# SERVICE BULLETIN

SB No. 143 Issue No. 1

**TITLE FAIREY HYDRAULICS MAIN UNDERCARRIAGE BACKLASH CHECK**
**CLASSIFICATION**

Fig 1  
PLACEMENT OF DIAL INDICATOR

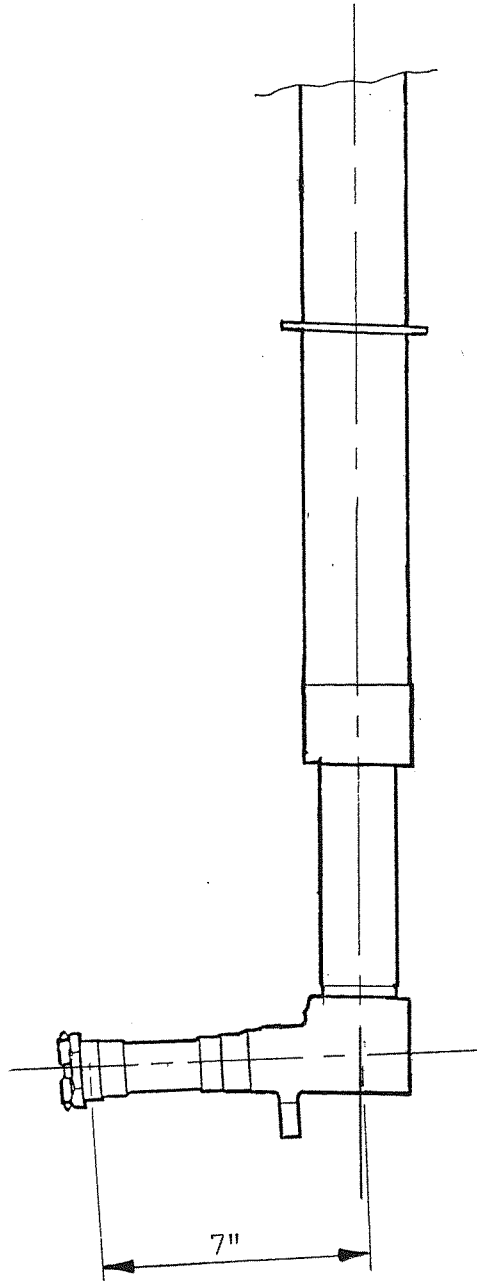
1. Support aircraft safely on jacks and remove main wheel and tyre assembly.
2. Measure 7 ins along the stub axle from the centreline of the plunger tube. See Fig. 1.
3. Set up dial indicator for up and down checks at the 7 ins position.
4. Establish a means to record the neutral position and zero the indicator.
5. Apply 2 lbs of force upwards. Measure and record the deflection.
6. With stub axle back to the neutral position and indicator set to zero, apply 2 lbs of force downwards. Measure and record the deflection.
7. Total deflection up and down must not exceed 0.020 ins.
8. Set up the equipment to record fore and aft deflections at the same 7 ins mark. Zero the indicator.
9. Apply 2 lbs of force forward. Measure and record the deflection.

10. With stub axle back to the neutral position and indicator set to zero, apply 2 lbs of force rearwards. Measure and record the deflection.
11. Total deflection forwards and rearwards must not exceed 0.040 ins.
12. If either of the requirements for maximum allowable deflection are not met, moving strut and stub assembly should be returned to manufacturer for inspection.
13. Annotate Log Book "SB 143" complied with".
14. The Maintenance Manuals will be amended to include this check at next issue.
